From:	Beggs, Tauren R - DNR
Sent:	Thursday, November 6, 2014 3:52 PM
То:	'James McDonald'
Subject:	RE: Eggers West Plant
Follow Up Flag:	Follow up

Thank you for the plan sheets. There are two separate issues I want to address for this project: 1) residual contaminated soil and 2) removal and replacement of the cap.

Attached should be a plan set for the Sanitary Sewer relay. Note that the phone conduit is atop the water main on the east end of the project. I believe that manhole SA7 has been placed.

14th St ROW-WI DOT 02-36-519548

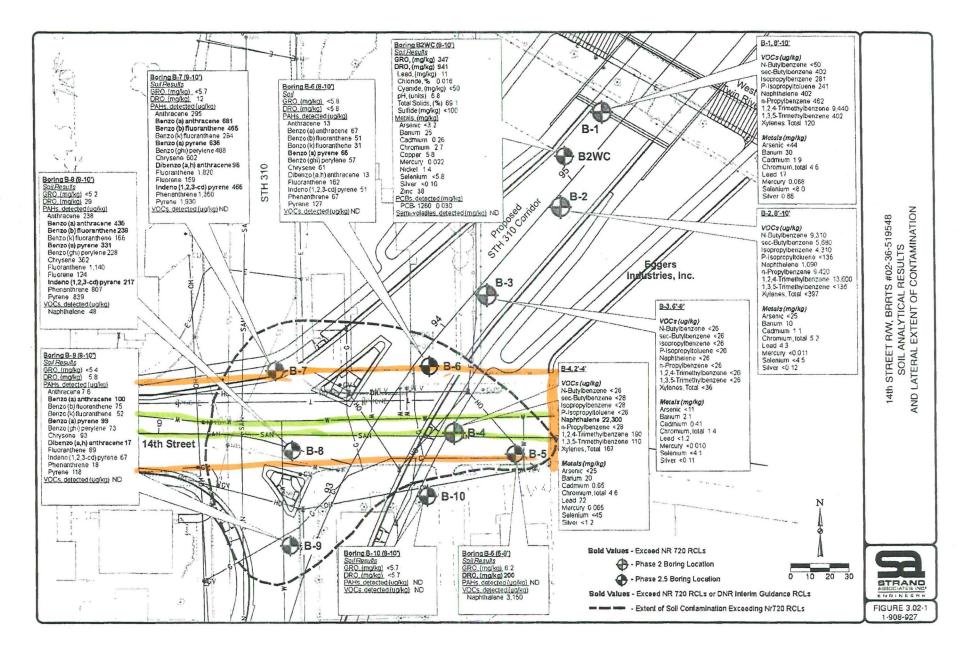
1) Based on the attached map from the closed BRRTS case, 14<sup>th</sup> St ROW – WI DOT, BRRTS # 02-36-519548 and the plan sheet you provided, it appears the extent of PAH contaminated soil is between 62+00 and 64+00 of your project limits. I highlighted the area on the attached map that relates to your current project. Since manhole SA7 has been placed, you should be at the end of the contaminated soil extent. For this project, the contaminated soil being reused for backfill is acceptable. If any contaminated soil was not used for backfill, it should have been properly handled and disposed at a licensed landfill. If any of the contaminated soil was placed at another site, it must be recovered and properly handled and disposed. If you discover any more contamination during the utility replacement that is not associated with these closed cases, please notify me. **Please submit any pertinent final documentation to me that explains what was completed once the project is finished, so I can use that information to determine if an update to the GIS Registry is needed for the 14<sup>th</sup> St ROW – WI DOT closed case.**

# Eggers Industries West Plt - WI DOT 02-36-521430

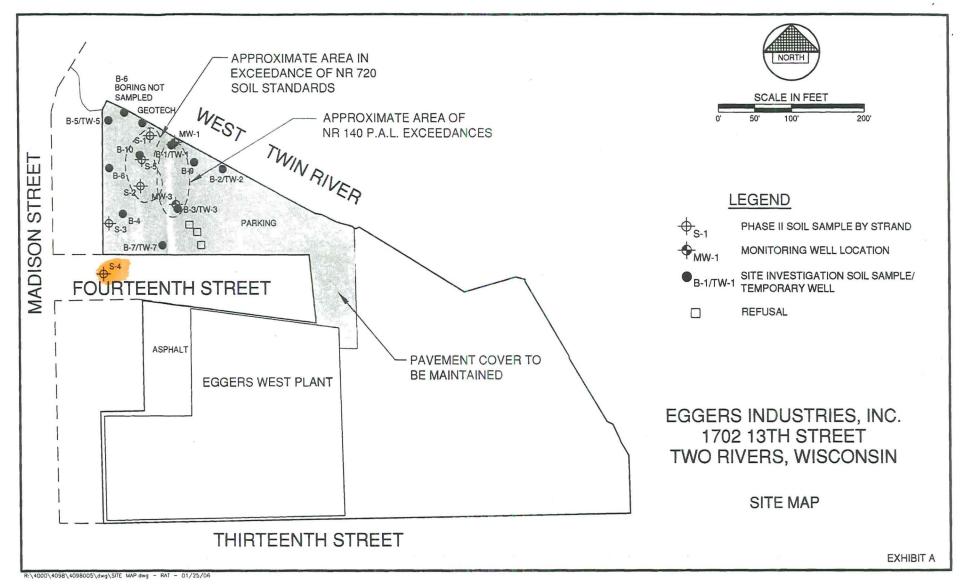
2) This project goes through part of a cap that is required to be maintained as a continuing obligation of the closed case Eggers Industries West Plt – WI DOT, BRRTS # 02-36-521430 (please see attached map for the shaded cap area). Notification to the DNR and approval is required prior modifying or removing a cap. I will accept your previous email as notification to the DNR and this email will act as your approval to proceed. Since you will be replacing/or have already replaced the current pavement cap with an equally impervious or more impervious cap, this will be acceptable; however, you are required to submit a Continuing Obligations Inspection and Maintenance Log (Form 4400-305), so it can be added as an update to the GIS Registry. On the log you will need to explain what changes you made to the cap. Also, take photos of the original capped area & the portion of the cap that you modified and attach the photos to the log. This log can be submitted by email; the link to the log is http://dnr.wi.gov/files/PDF/forms/4400/4400-305.pdf.
